HISTORIC LANDMARK COMMISSION
CERTIFICATE OF APPROPRIATENESS
MAY 24, 2021
HR-2021-039343
SMOOT/TERRACE PARK HISTORIC DISTRICT
612 HIGHLAND AVENUE

Construct a 1-story house with a lower level and partial basement; renovate the existing garage.

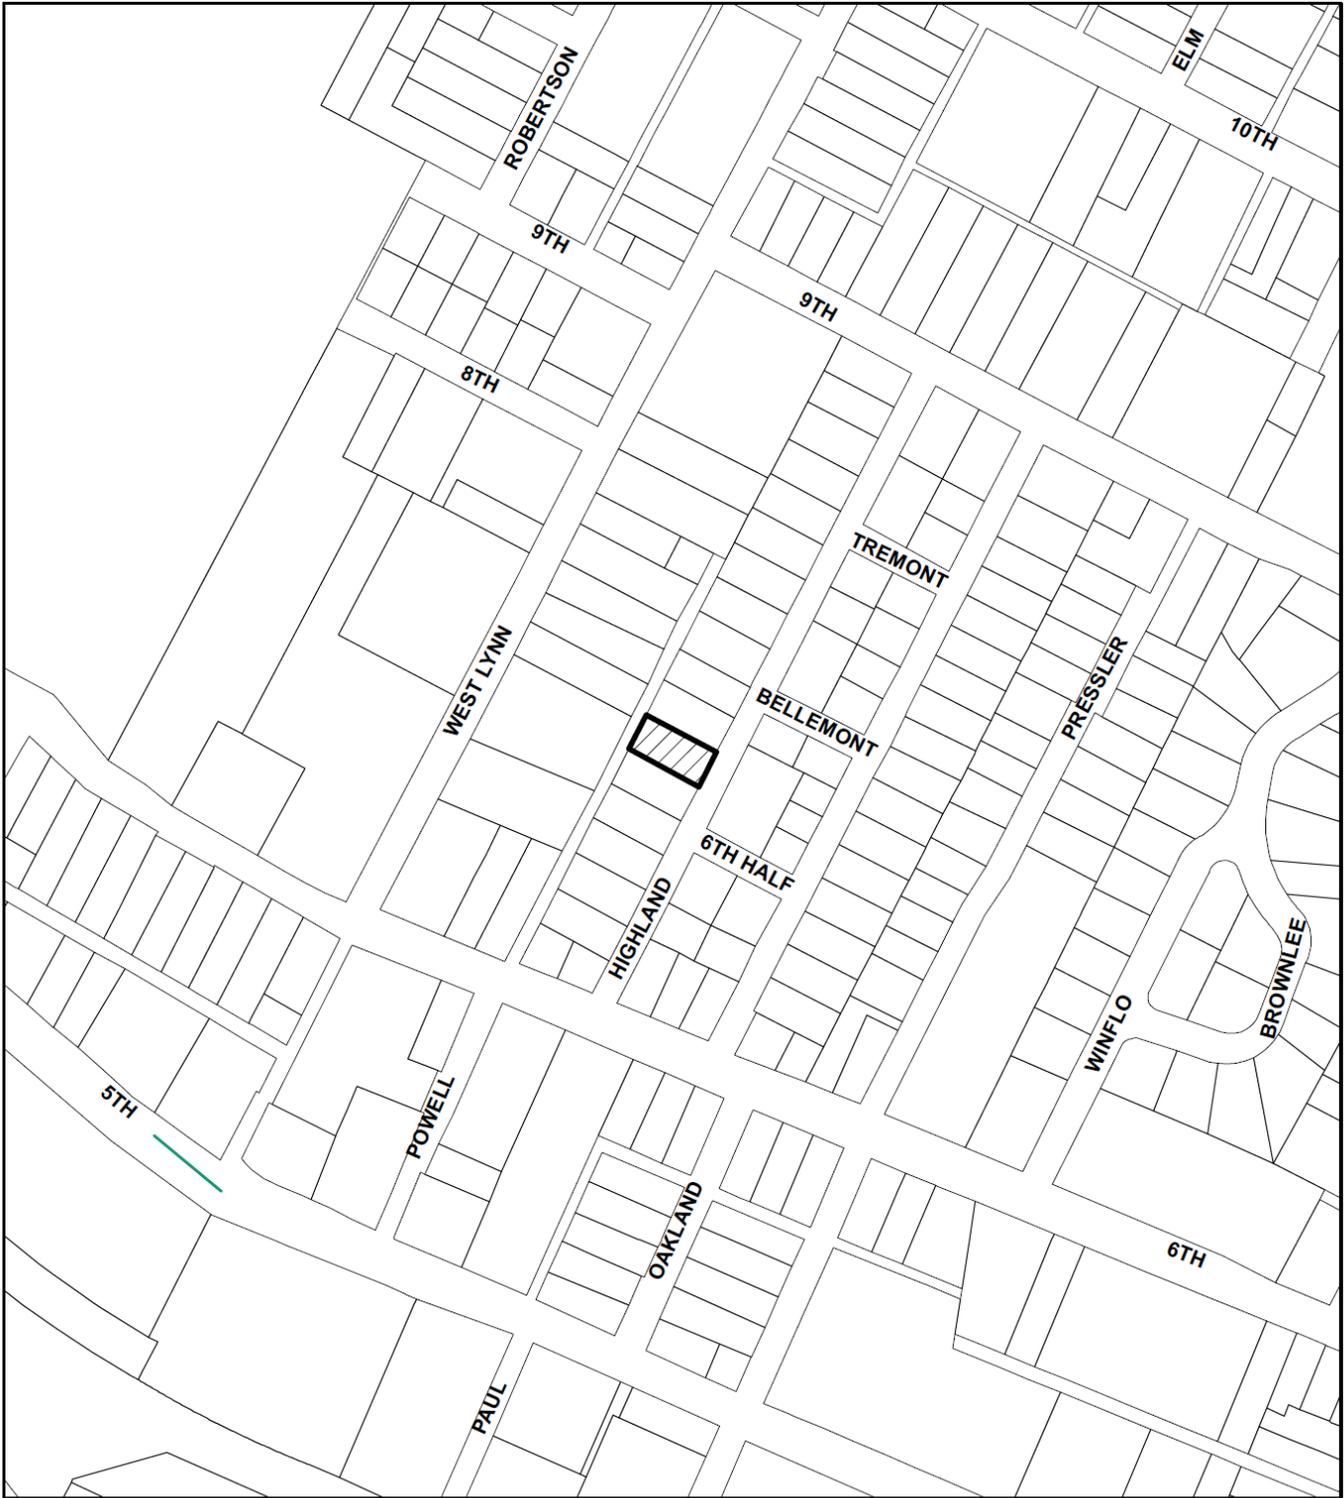
The building's scale and massing are compatible with nearby historic buildings. Elements such as the hipped roof form, dormer window, and full-width front porch present a modern take on historic architecture found elsewhere in the district. The triple banks of windows on the front wall and in the dormer reference window patterns in nearby historic buildings, with more vertical proportions that are compatible with the modern style and steeper roof pitch. The horizontal siding and porch railing reference cladding and porch elements on nearby historic buildings.

The project generally meets the standards.

The committee commended the front porch, front dormer, and material choices. Members commented on the absence of porch posts, but did not feel those were essential elements.

Approve the plans.
